Attachment A

<h2>Summary of Submissions</h2>
--

Figure 3: Western site layout - through site-links, retail activation and access

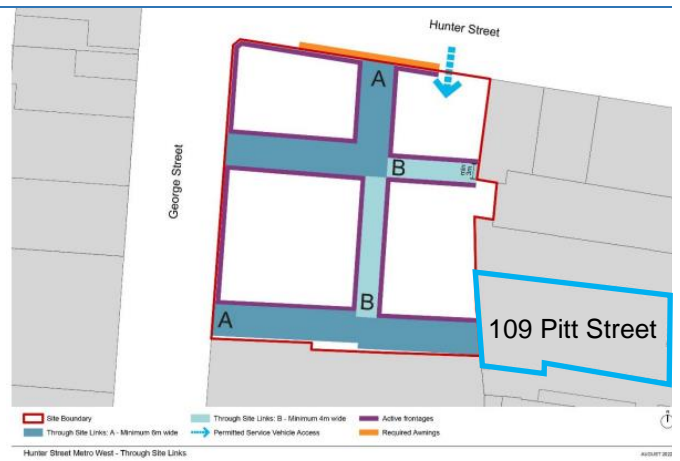
<p>3 individual submissions</p>	<p>Support –</p> <ul style="list-style-type: none"> • Make the transit development as big as possible • For a world class city, we must build world class buildings. Space is limited so we have to have optimum scale for our buildings. As long as buildings are well designed lets reach for the sky. Get on with making Sydney a world class city. • I am supportive of the new Hunter Street Station. I support the construction of new commercial and retail spaces. I support the new tunnels linking the new Hunter Street Station to Martin Place and Wynyard Stations. 	<p>Noted</p>
<p>16 individual submissions</p> <p>Adjoining Landowners</p>	<p>Reinstatement of existing pedestrian connections –</p> <ul style="list-style-type: none"> • Concern that there is no guarantee that the Hunter Connection will ever be re-connected to the future development on the Sydney Metro West Hunter Street Station western site. • Sydney Metro provides no assurance that Hunter Connection would be re-opened as part of the project. Reconnection to the Hunter Connection will be decided by the tendering development for the over station development, driven by their commercial interests. • The Hunter Connection is an essential part of Sydney’s pedestrian network and provides a direct and weatherproof connection from the central business core of Pitt Street through to Wynyard Station and Barangaroo. Maintaining this fully covered pedestrian links must be a requirement. • Reinstating the connection should be a requirement for the development at miniscule additional cost to the development. • The objective to create a significant precinct around the over-station development is difficult to reconcile without reconnection. They are creating retail slums and removing the benefit of undercover connections. • Development must include the re-connection of the Hunter Connection to ensure this Sydney icon is maintained as part of the larger Sydney Metro project. • This will adversely impact retail on Pitt Street with no through access and devalue the lots of landowners. • Currently 109 Pitt Street (which houses the Pitt Street portion of the Hunter Connection arcades) facilitates employment and business opportunities for more than 2,000 people. Maintaining an ongoing connection to 109 Pitt Street to the Sydney Metro project will not only enhance convenience, it enhances the use of public transport and support the local retail economy. • People with disability use the Hunter Connection as an accessible route to Wynyard Station, the removal of the connection would make access more difficult via public footpaths. Ease of access to public transport is a key consideration to an inclusive workplace. • The people of Sydney were never informed of the potential permanent closure of the Hunter Connections in the 	<p>Hunter Connection comprised retail tenancies, a food court and an underground link between Wynyard Station, Hunter Street and Pitt Street through the 109 Pitt Street Building, as shown in Figure 1 below. The Hunter Connection building was acquired by Sydney Metro and forms part of the future Hunter Street Station western site.</p>  <p>An objective of the Design Guidelines is to “Improve permeability, pedestrian movement and connectivity with the provision of generous retail activated through-site links”. The provisions detail the locations of future through-site links for greater permeability, movement and connectivity and to reinstate existing and historical connections.</p> <p>The below figure from the Design Guidelines shows the location for any future through-site connections from the western site. As shown, it is recommended a connection is maintained into the 109 Pitt Street site (shown in blue), maintaining links to this section of the former Hunter Connection.</p>

The indicative design that accompanies the concept SSDA includes through-site links, demonstrating the subject sites are capable of incorporating pedestrian connections as detailed in the Design Guidelines. This will be further resolved through the detailed design and development application stages where issues relating to level alignment and heritage will need to be resolved. The City will continue to advocate for the detailed design to address this provision. It is recommended the owners of 109 Pitt Street continue to actively engage with Sydney Metro and the Department of Planning and Environment to ensure this pedestrian link is reinstated.
